OFFICIAL COORDINATION REQUEST FOR NON-ROUTINE OPERATIONS AND MAINTENANCE

COORDINATION DATE- 15BON45 WS LFS air entrainment test PROJECT- Bonneville Lock and Dam RESPONSE DATE- 23 July 2015

Figure 1. Isometric rendering of the Bonneville Washington Shore Lamprey Flume System.

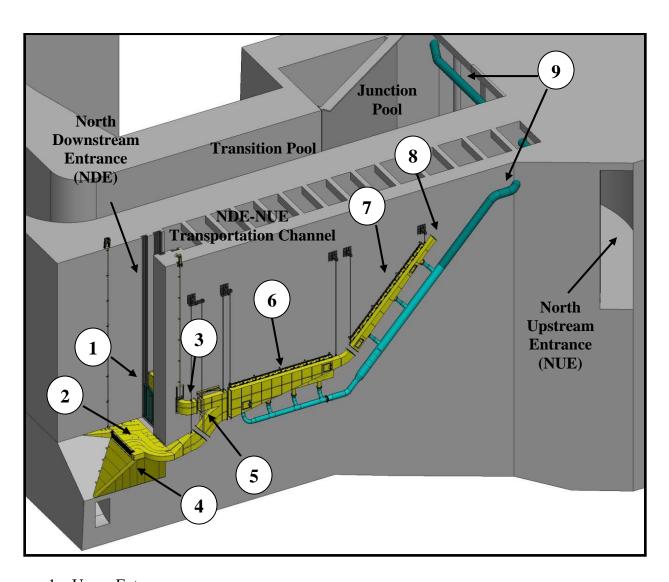
Description of the problem- Corps personnel first identified an air entrainment issue with the Bonneville WA Shore Lamprey Flume System (LFS, **Figure 1**) in June 2013. Corps biologists and FPOM representatives are concerned about the potential impacts of large volumes of air boils/bubbles on salmon and steelhead passage behavior in the vicinity of the North Downstream Entrance (NDE, **Figure 2**). In 2013 and 2014, surface observations of the entrained air plume led to daytime restrictions on flow settings (valve openings). See MOCs 14BON42 and 14BON14 for reference.

Small-scale air venting modifications to the LFS system in 2013 and 2014 were not successful and the Corps design team is currently evaluating potential solutions, including operational adjustments. No-cost changes under consideration include (a) partially closing an air vent that is contributing to the problem; (b) partially closing the knife gate leading to upper entrance of the LFS, thereby providing a blockage that will force air to leave the system away from NDE.

Tammy, Also, the 29th (of July) also just happens to be the day the Portland District chose for the Bonneville Dam performance study meeting, which most of these people (including Sean) should be attending. I notice that the dates of impact are 29-30, July, however the next paragraph says this will take three days....? Also, normally I would agree with the implication that a short delay of fish is likely of little consequence without sea lions in the tailrace, however, not at these water temperatures. Under the length of time paragraph, the words "as practicable" should be deleted. Unless the ROV inspection is occurring, any testing above the 40% level should be done off peak passage hours. Overall, I'm not really comfortable with doing this test this time of year given the issues we are seeing for adult passage this year. Thanks, Gary

Complete any and all higher-flow (>40%) testing during the ROV inspection, when attraction to the ladder will be minimal. Testing will only be done between 1000 and 1400 (off passage peak hours). The PDT will identify the critical >40% valve opening treatments to look at and work closely with BON. Consider changing LFS ops as appropriate for the remainder of the season. Come back before 15 December to evaluate the full range of treatments.

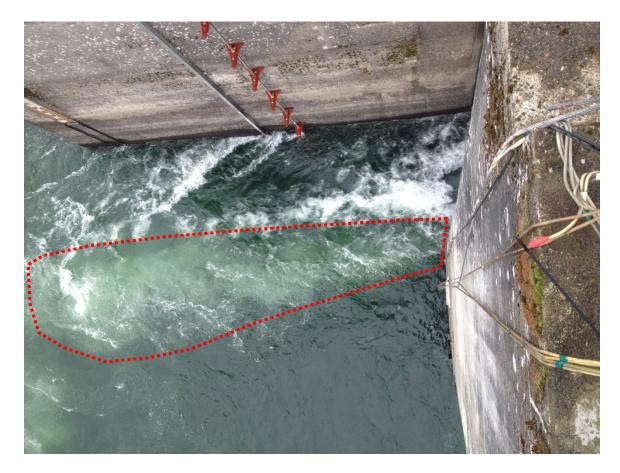
The Corps anticipates that operation of the LFS at the higher flow settings (above 40% valve opening) will result in a visible plume of air immediately downstream of the NDE, potentially causing temporary migration delay fish attempting to enter the fishway. Due to the intermittent nature of the testing and the time of year (no sea lion predation), there will likely be little impact on adult salmonids or lamprey as a result of the operation. This test will partially coincide with the ROV inspection of the WA Shore Ladder, which means reduced overall fish attraction to Powerhouse 2 and the fishway entrances.

- 1. Verified that all air that is discharging on the fishway side (in vicinity of NDE and the upper flume) is emanating from the thimble, thereby "hugging" the south wall of the fishway entrance area, regardless of the treatment. In other words, just as we suspected, the entrained air isn't evenly distributed across the width of the NDE. This is good from a salmon passage standpoint.

- 2. Partial gate closure had a very significant effect on presence of entrained air in the NDE area (on the fishway side of the wall). In fact, the only operations of major concern occurred when the gate was fully open (normal operation) and the butterfly valve opening was above 60%.

- 3. With the gate fully open, there was a clear threshold somewhere between 50% and 55% in which we went from seeing zero air inside the fishway to seeing a slight, but steady, boil in this area. Concurrently, there was very little air visible on the outside of the fishway, along the bulk of the LFS. Thus, the LFS is able to vent air properly and with almost no discernible effect on the tailrace at about 50% valve opening. 60% didn't look too bad at all and is our current cap.

- 4. The PDT will be recommending some combination of gate closure and higher discharge. One possible "sweet spot" that appeared to strike a good balance of lamprey attraction flow, velocity within the flume in the vicinity of the gate, and presence of entrained air involved a 1 ft gate opening (about 25% of fully open position) and 70% butterfly valve opening. At this setting, there was a light stream of bubbles from the thimble area, with an intermittent and relatively light boil approximately every 40-50 seconds.

At the end of the testing, the team compared notes and decided to leave the flume setting at 1 ft gate opening and 60% valve opening (on local control). This should be considered an interim operation until we can discuss test results with FPOM and agree on setting that will at least get us through the end of the current passage season. I'll reach out to FPOM on this once the PDT has put together our notes. Brian McIlraith was present and may be able to share his observations as well.
